23-00399-00-MG

Maint. Garage Locker Room Addition - Milan Yard

This addendum forms a part of the bidding and contract documents. This Addendum supersedes and supplements all portions of the original bidding and contract documents dated 10/21/2024, with which it conflicts.

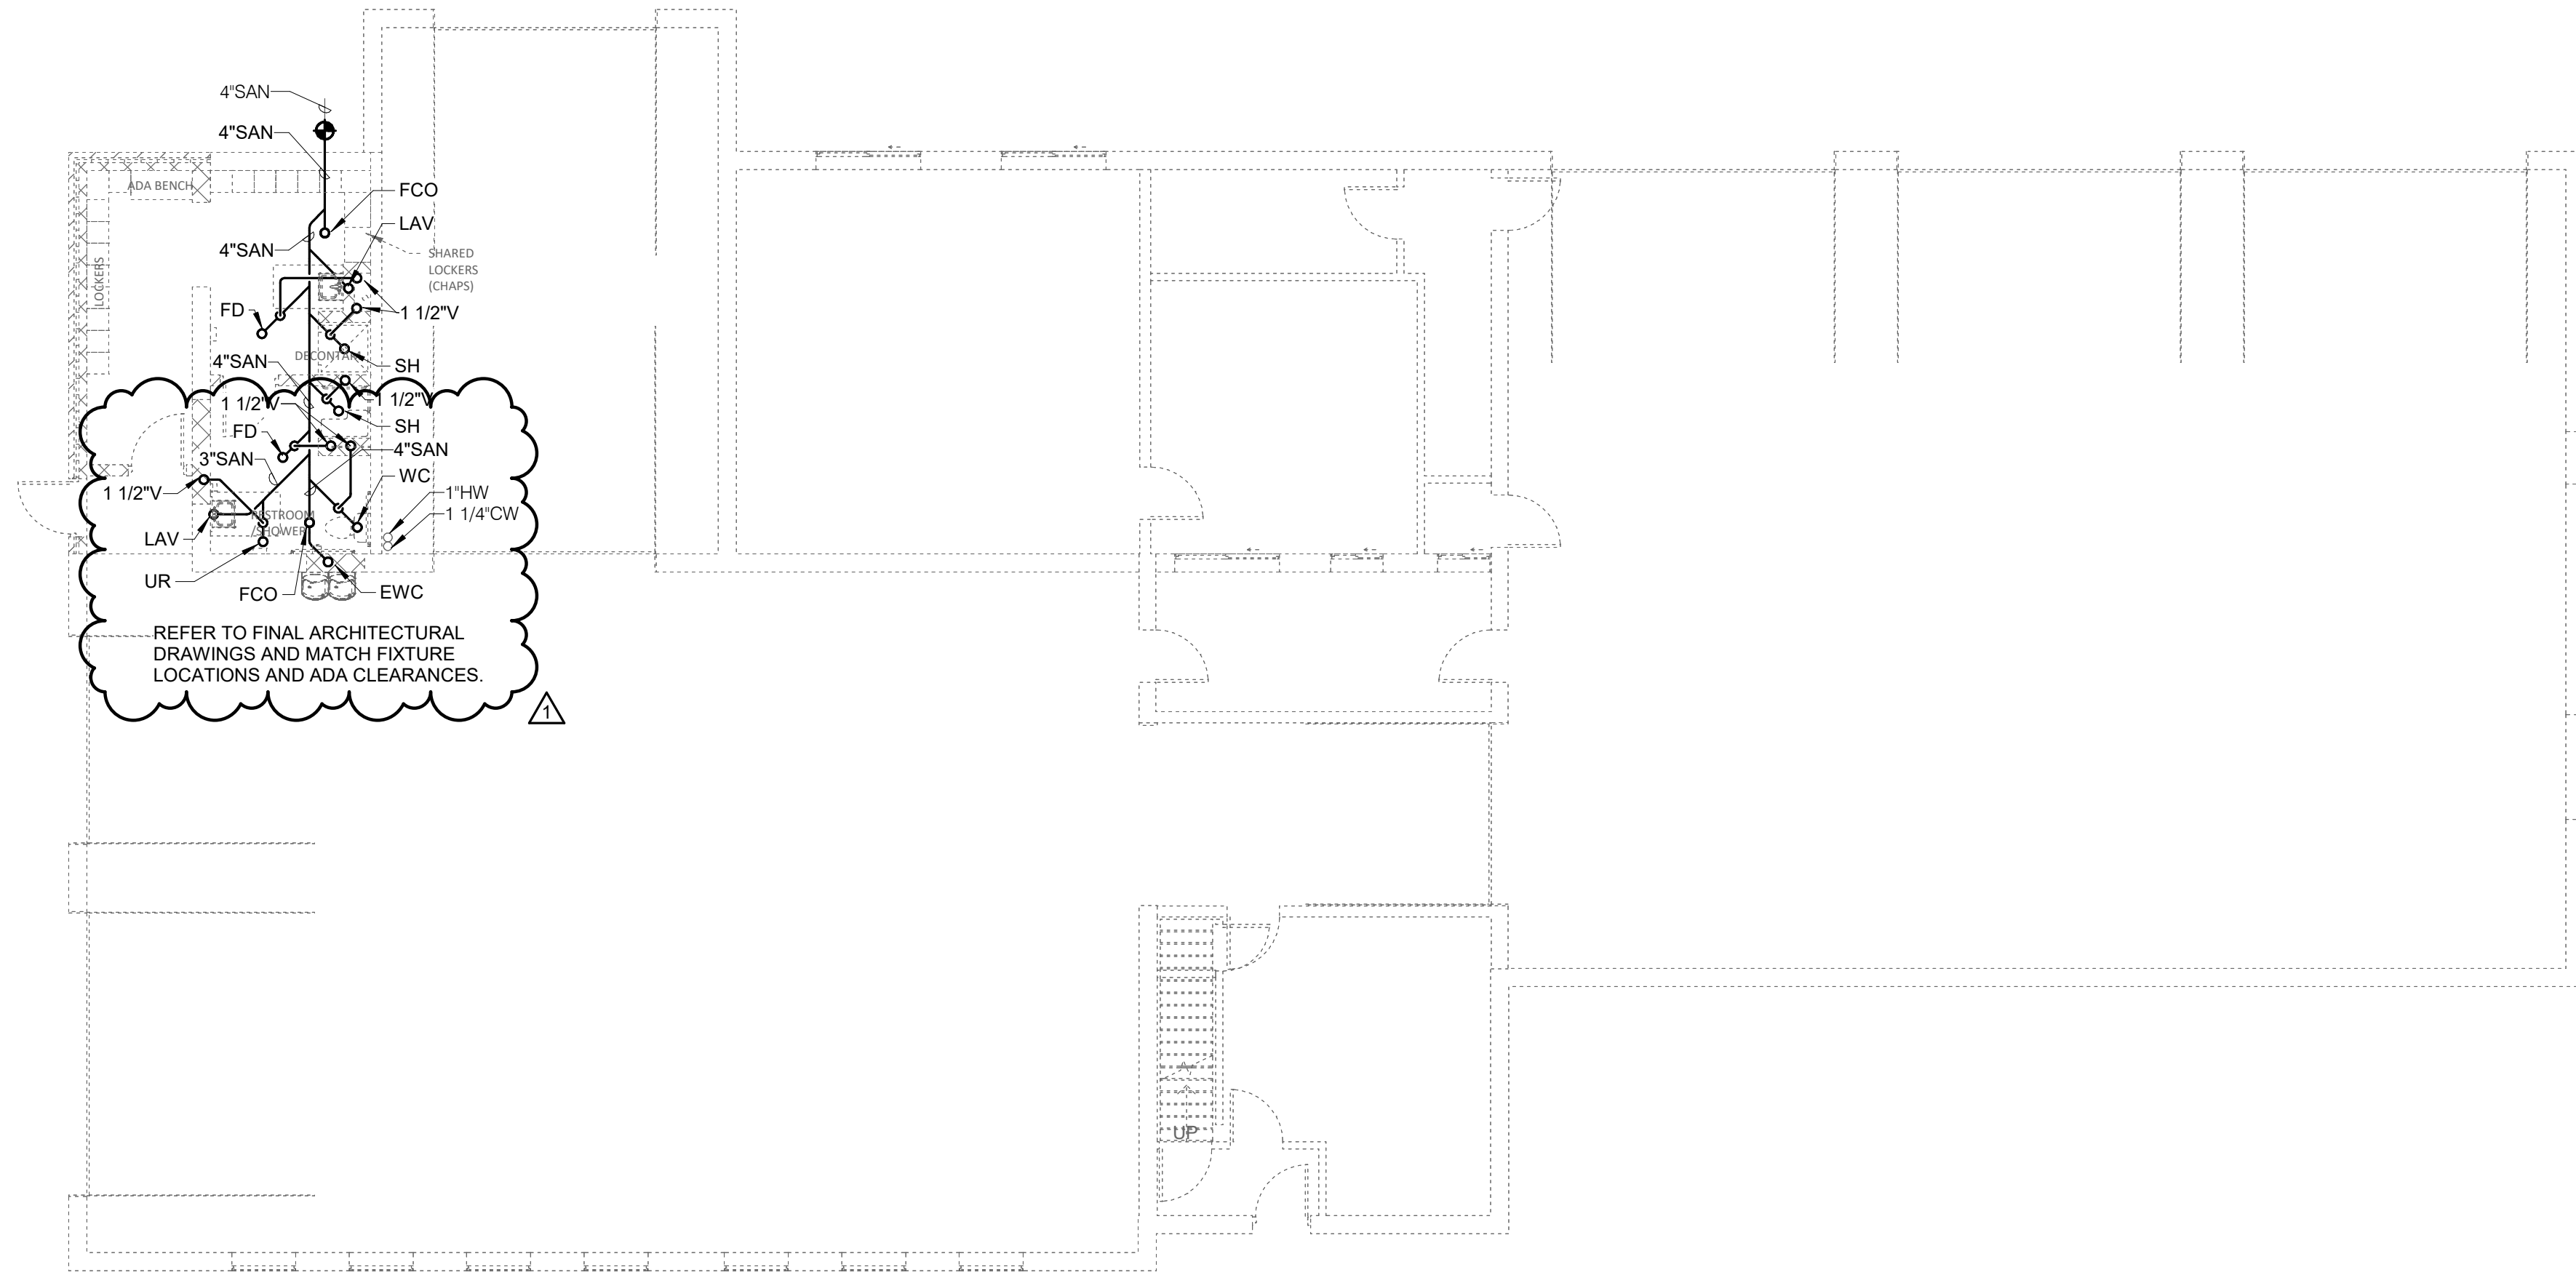
1. **SHEET P0.00 – PLUMBING COVERSHEET**
 - a. Plumbing Rough-In Schedule
 - i. **ADD** UR-2 to Plumbing Rough-In Schedule
 - ii. Refer to re-issued sheet

LEVEL 1 PLAN - PLUMBING - RESTROOM / LOCKER ROOM

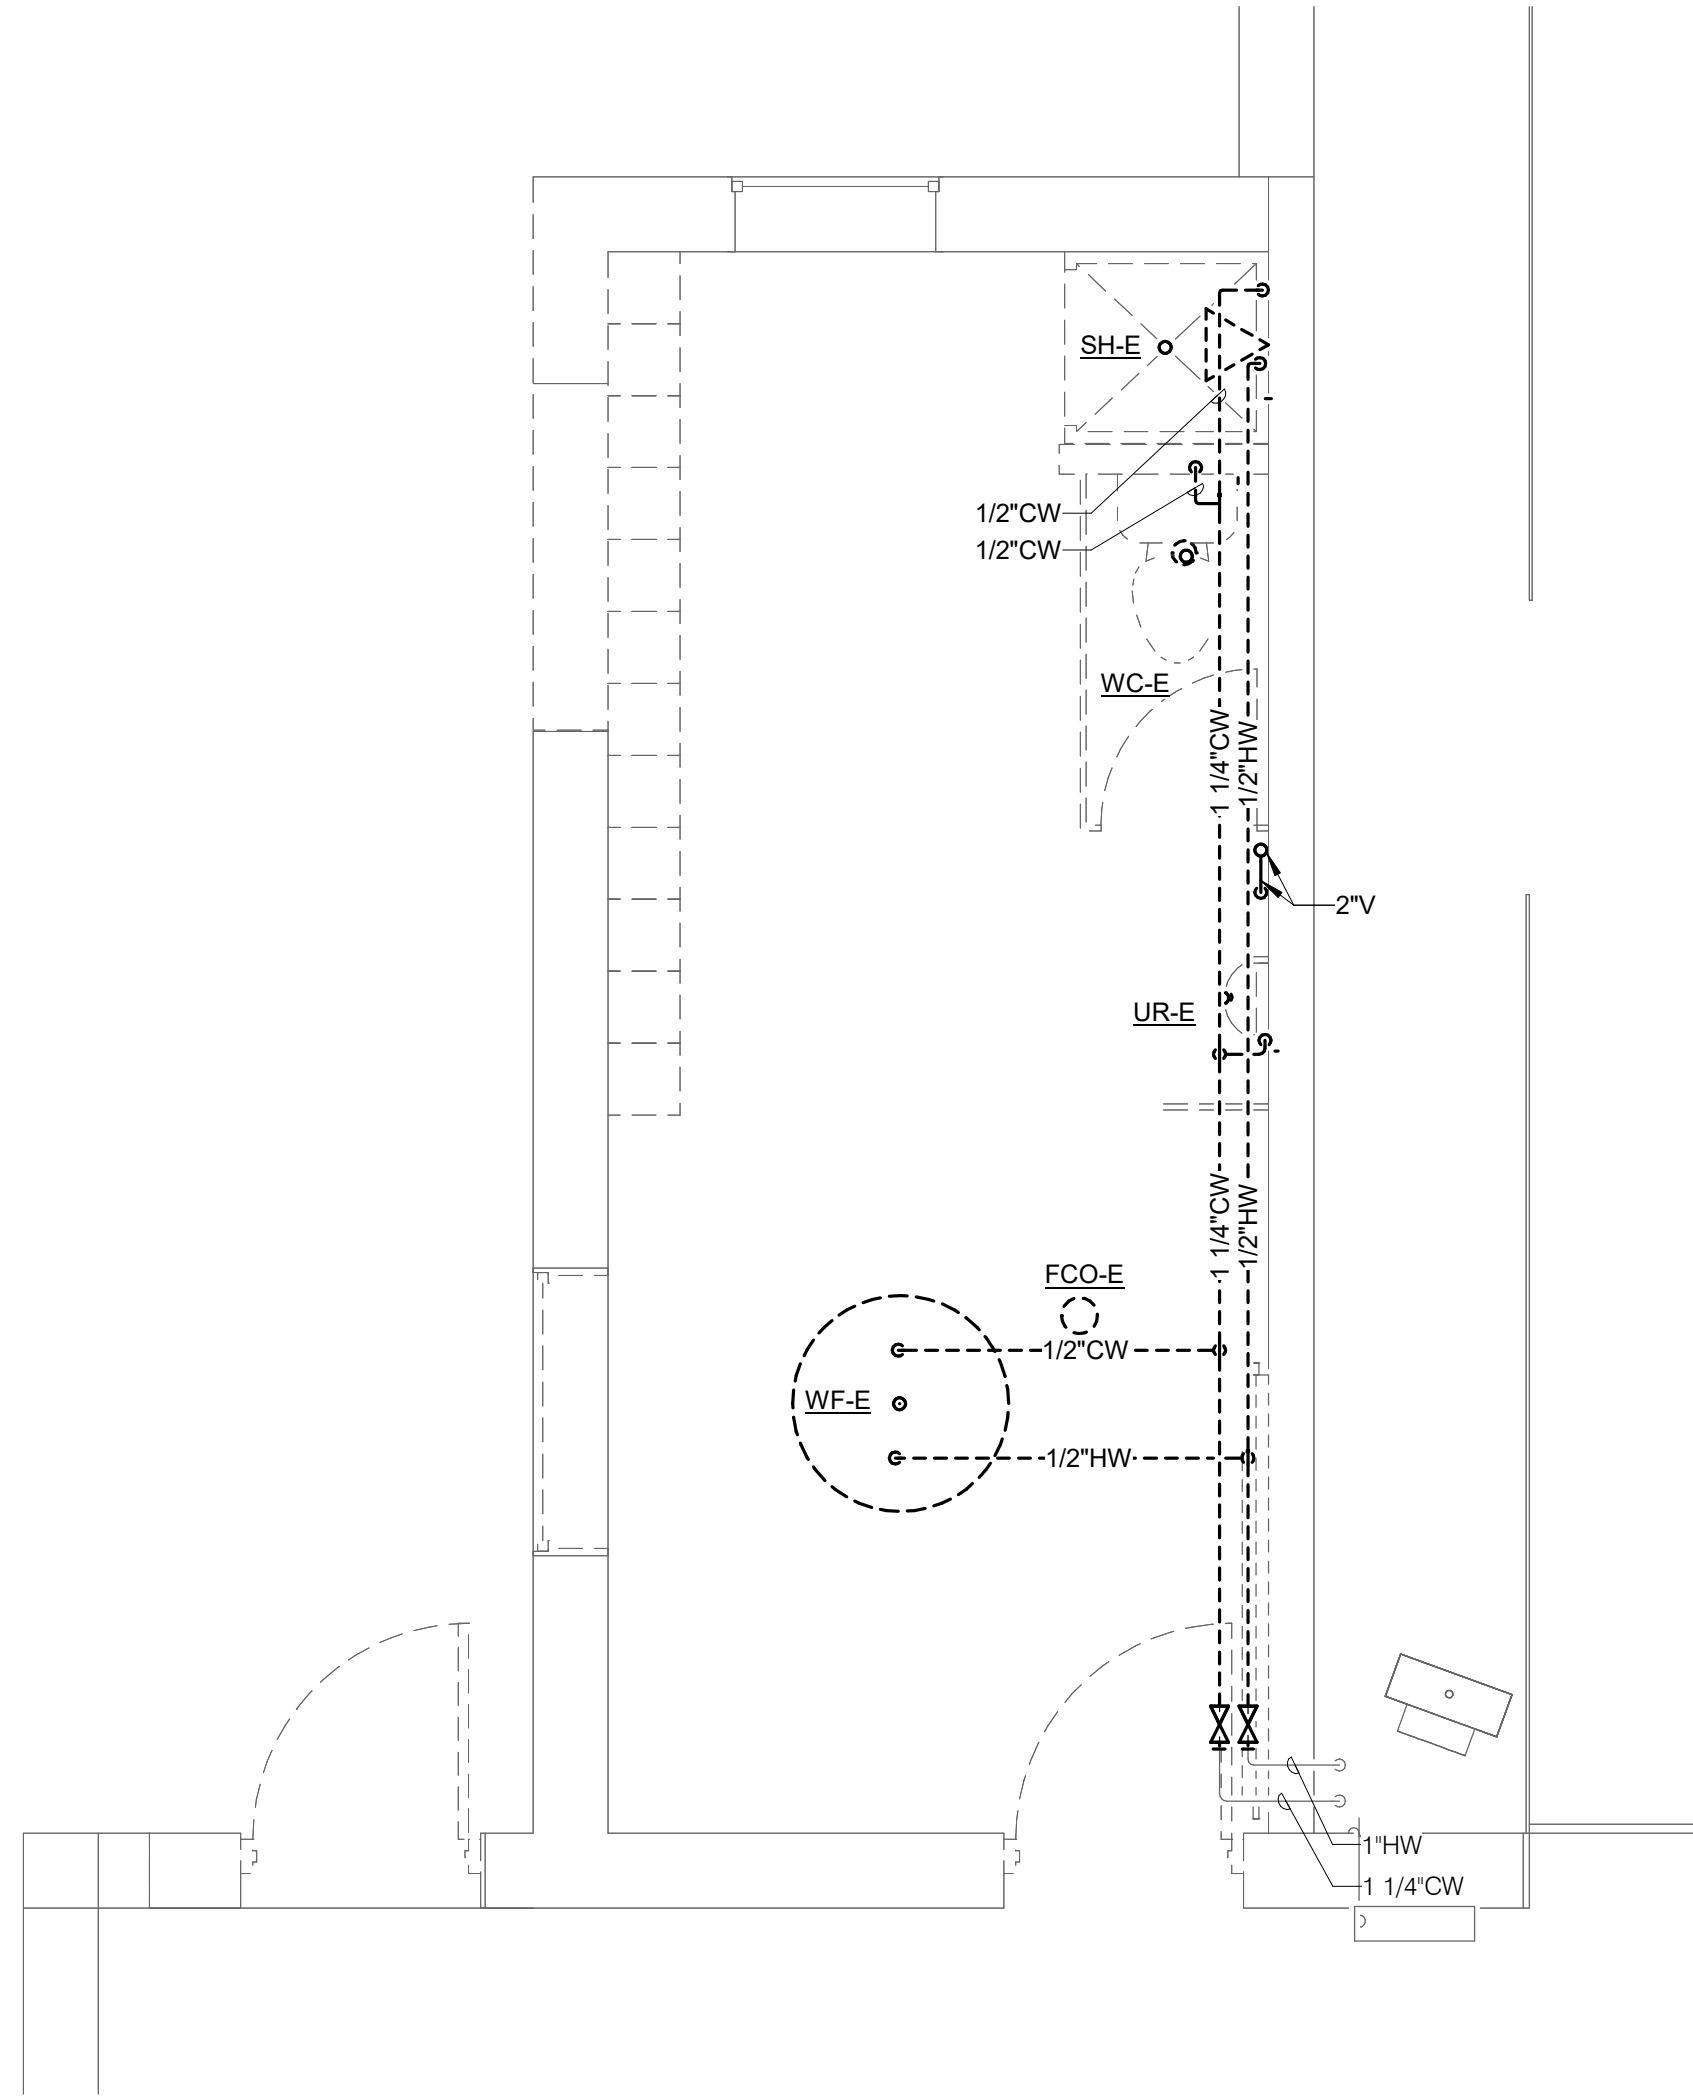
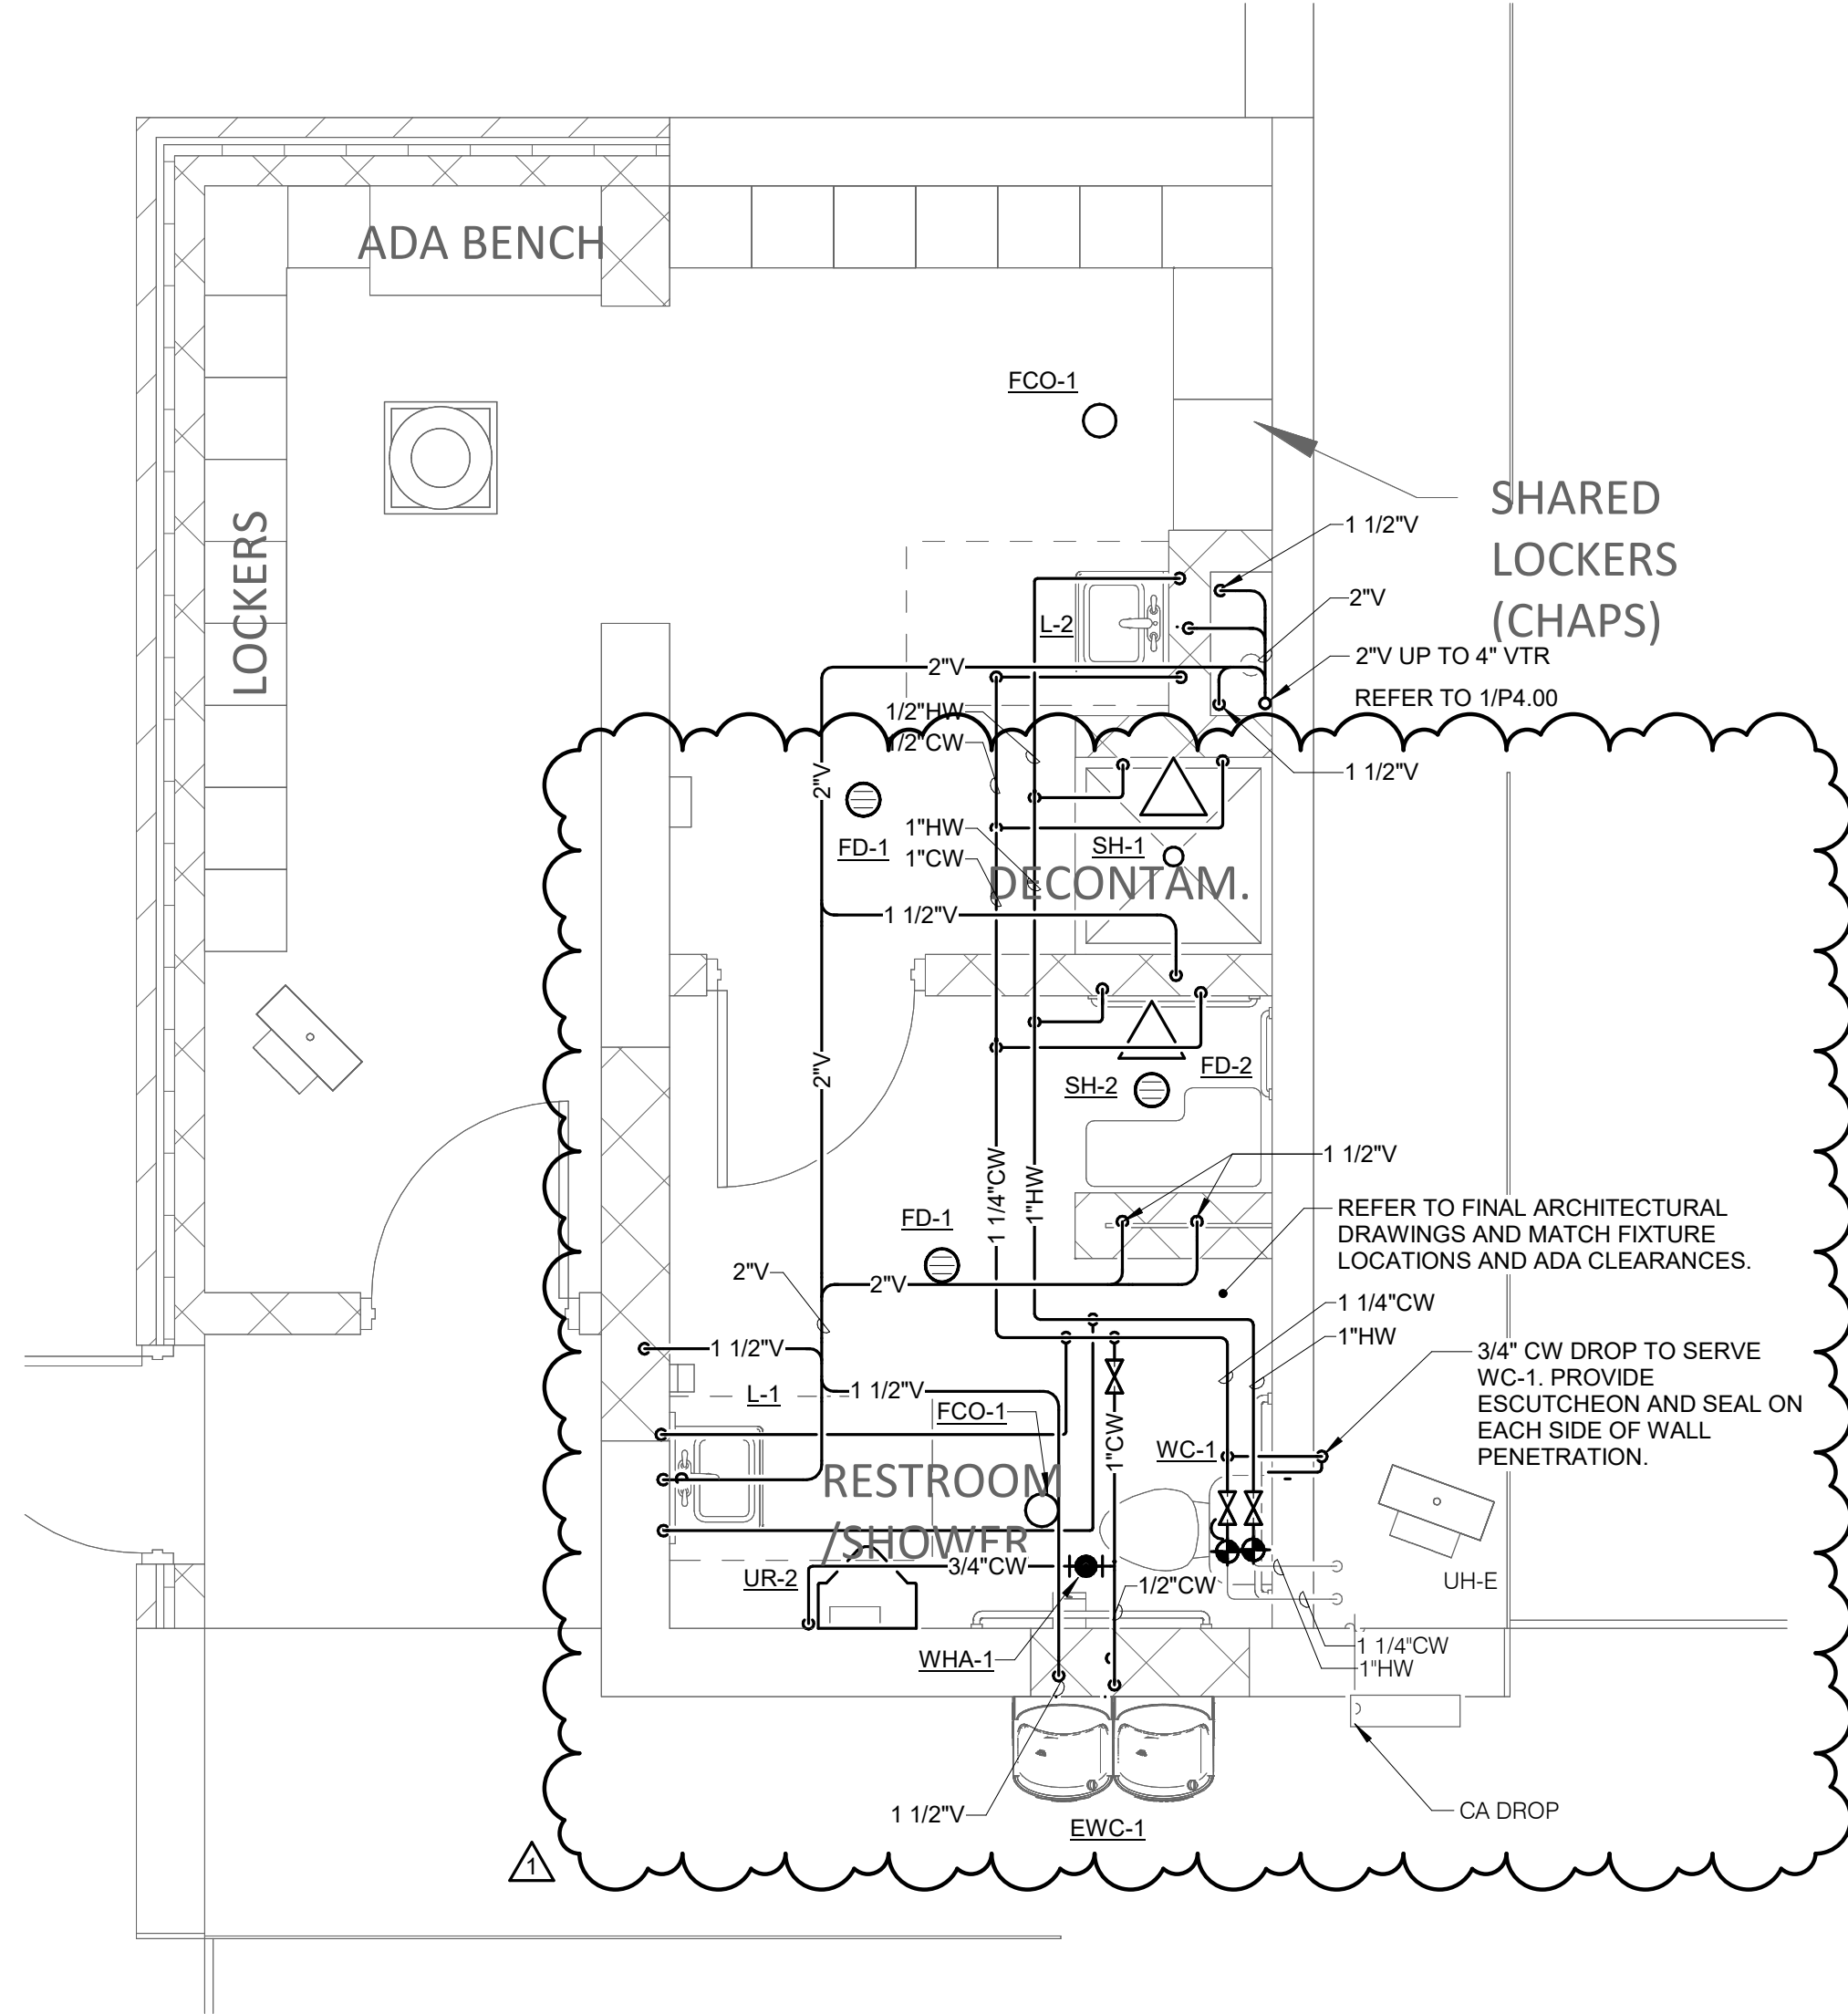
2. **SHEET P1.00 – UNDERFLOOR PLANS - PLUMBING - MAINT**
 - i. **ADD** UR-2 and associated SAN and Vent piping.
 - ii. **ADD** note to 2/P1.00 to read; “REFER TO FINAL ARCHITECTURAL DRAWINGS AND MATCH FIXTURE LOCATIONS AND ADA CLEARANCES.”

- iii. **ADD** and **REVISE** plumbing tags.
 - iv. Refer to re-issued sheet.
3. **SHEET P3.00 – PLUMBING ENLARGED PLANS**
 - i. **ADD** UR-2 and associated CW and Vent piping.

- ii. **ADD** WHA-1.
 - iii. **ADD** note to 2/P3.00 to read; “REFER TO FINAL ARCHITECTURAL DRAWINGS AND MATCH FIXTURE LOCATIONS AND ADA CLEARANCES.”
 - iv. **ADD** and **REVISE** plumbing tags.

- v. **REMOVE** FD-2 serving SH-1.
 - vi. Refer to re-issued sheet.
4. **SHEET P6.00 – PLUMBING SCHEDULES**
 - i. **ADD** UR-2 and WHA-1 to plumbing material list.
